Commonwealth Edison
 One First National Plaza, Chicago, Illinois
 Address Reply to: Post Office Box 767
 Chicago, Illinois 60690

Subject: LaSalle County Station Unit 2
 Facility Operating License NPF-18
 Condition No. 4 of Attachment 2
 NRC Docket No. 50-374

This letter is submitted to comply with a LaSalle County Station Unit 2 license condition [reference (a)]. The attachments to this letter constitute a procedures generation package to upgrade LaSalle's emergency operating procedure to BWROG Rev. 3.

A

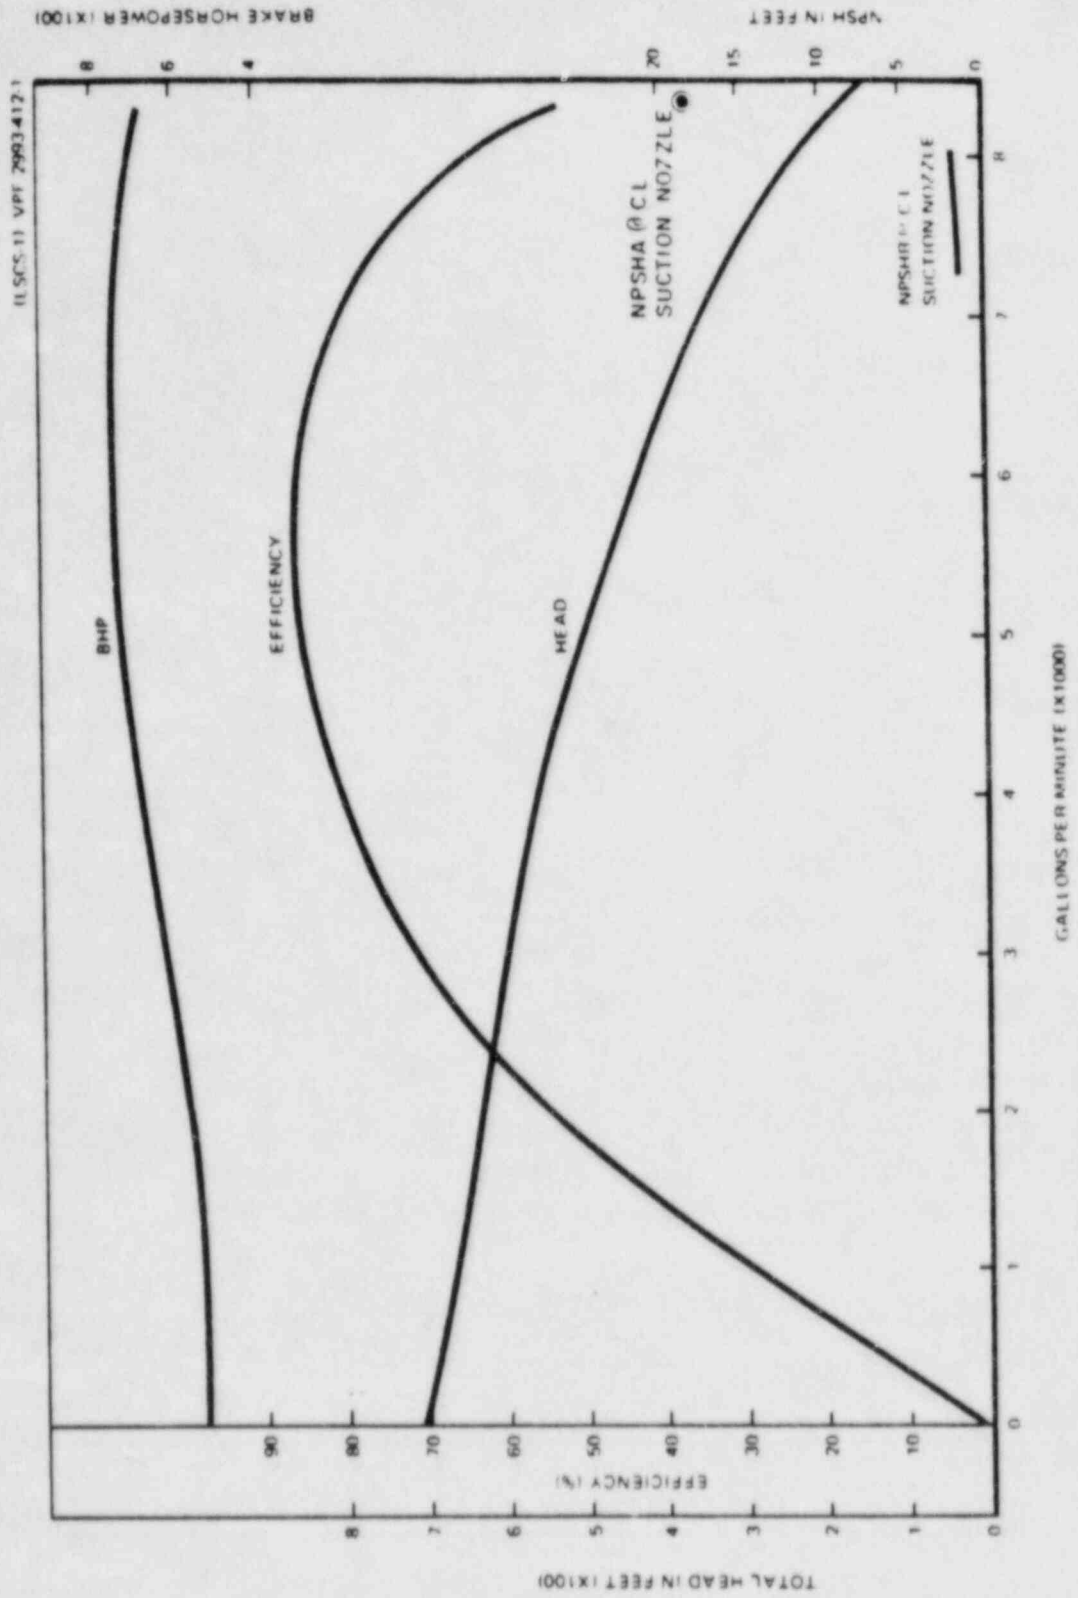
Since the Technical Specifications permit MSIV isolation in hot standby, this should not require entry into the RPV Control Guideline and a subsequent scram per Step RC-11 the entry condition needs to be limited to isolations which require a scram.

Resolved entry conditions deleted as it is no longer required with Radioactivity Release Control Guideline.

J

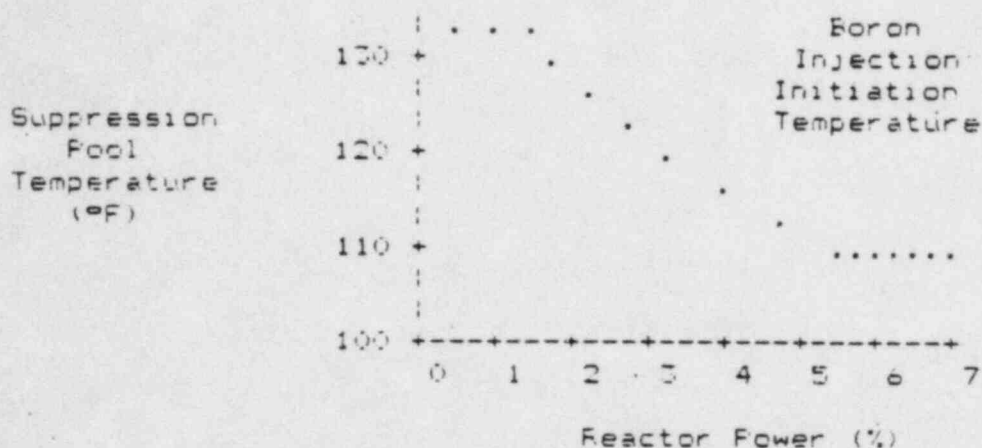
Rod insertion criteria should be "..rods at or beyond [06..",
not "..rods beyond [06..".

Resolved all references
to rod insertion criteria
changed to "..at or beyond
[06..".

L

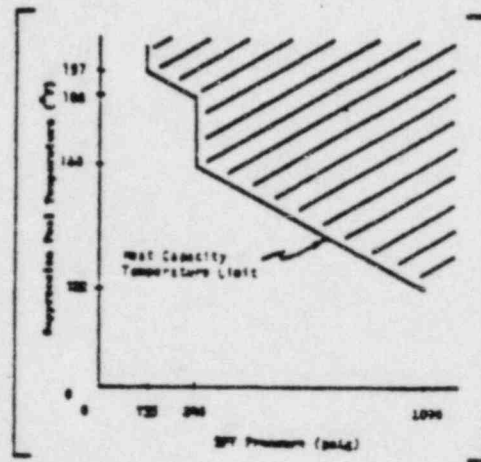
The manual scrae should be initiated only after the SDV has had a chance to drain; the step needs to reflect this waiting period.

Resolved changed step to read "Drain the scrae discharge volume and initiate a manual reactor scrae;" utilities to discuss proposed change with operators and prepare for discussion at next EPC meeting.

Resolved 3/10/84: step changed as proposed.
